Route Access Condition Notice 20-0007

Distributed To:	ARTC Website
Distribution Date:	03/03/2020
Requested By:	ARTC
Subject:	Changes to loop length for clearances at Bulliac
Effective Period:	Until Published
Amendment Type:	Permanent (to be added to RAS)

Section: Section Page D33 **Version No.:** 2.0 **Page/s:** 2

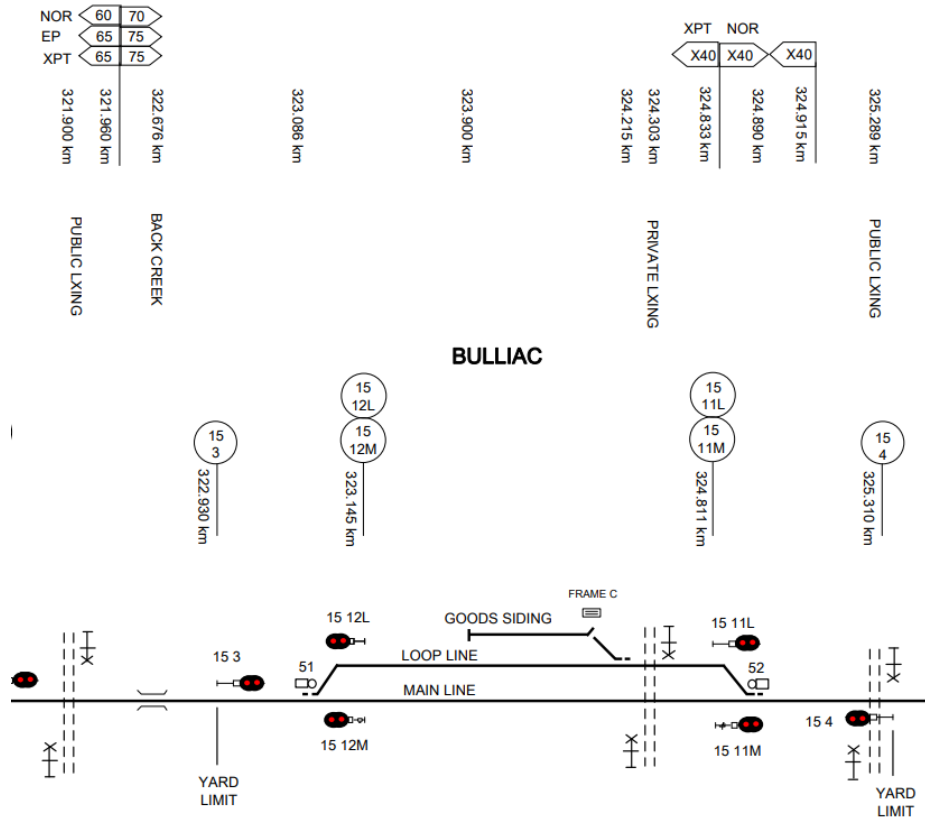
RAS Diagram at Bulliac changed to reflect signal to signal clearance loop length of 1666m as show in the Network Information Book.
